Access Compliance Report

Public Rights-of-Way

(Curb Ramps)

Intersection ID: 43248	Main Street: LAMPLIGHTER_PL	Cross Street: STONEMAN_DR	Location: NE
ADA ID: 376D94B92495	Ramp Type: BlendTrans2	Initial Pass/Fail: Fail	Overall Compliance: No
Severity Score: 47.5			
Codes/Mitigation Info/Possible Solution		Field Measurements/Component Compliance

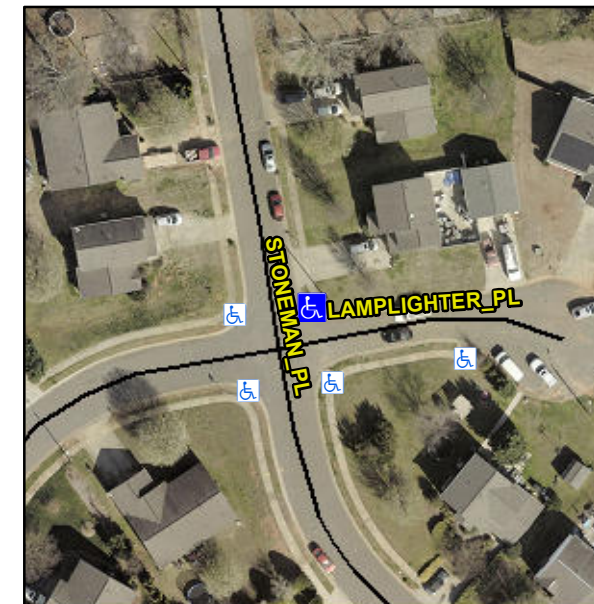
R304.5.1, R304.5.3

Compliance	Description	Data	Compliance	Description	Data
N/A	Ramp Length (in)	93.0	Yes	BlendTrans Slope (%)	2.8
No	Ramp Width (in)	30.0	No	BlendTrans XSlope (%)	5.7
N/A	Flare Type LT	N/A	N/A	Flare Type RT	N/A
N/A	Flare Slope LT (%)	N/A	N/A	Flare Slope RT (%)	N/A
N/A	Flare Traversable LT?	N/A	N/A	Flare Traversable RT?	N/A
N/A	Landing Length (in)	N/A	N/A	DWS Provided?	N/A
N/A	Landing Width (in)	N/A	N/A	DWS Contrast?	N/A
N/A	Landing Slope (%)	N/A	N/A	DWS Length (in)	N/A
N/A	Landing X Slope (%)	N/A	N/A	DWS Full Width?	N/A
N/A	Landing Curb? (Y/N)	N/A	N/A	DWS Offset (in)	N/A
N/A	Shared Landing?	N/A			
N/A	Gutter Ponding?	N/A	N/A	Gutter Slope (%)	N/A
N/A	Gutter Lip Ht (in)	N/A	N/A	Gutter X Slope (%)	N/A
N/A	Painted X Walk1?	No	N/A	Painted X Walk2?	No
	X Walk 1 Direction	To W		X Walk 2 Direction	To S
	X Walk 1 Width (in)	N/A		X Walk 2 Width (in)	N/A
	X Walk 1 Slope (%)	1.3		X Walk 2 Slope (%)	3.8
	X Walk 1 X Slope (%)	4.9		X Walk 2 X Slope (%)	2.3

N/A	Ramp inside XWalk1?	N/A	N/A	Ramp inside XWalk2?	N/A
	Road Slope (%)	4.8		Clear Space?	N/A
	Road X Slope (%)	2.3	N/A	Clear Space to XWalk (in)	N/A
N/A	Any Obstructions?	N/A	N/A	Storm Grate/Utility Hazard?	N/A
	Obstruction Type			Storm Grate/Utility Type	
		N/A			N/A
			Yes	Surface Condition? (G/P)	Good
			N/A	Curb Slope (%)	1.2

Remove & Replace Curb Ramp With Two New Directional Ramps or Equivalent.
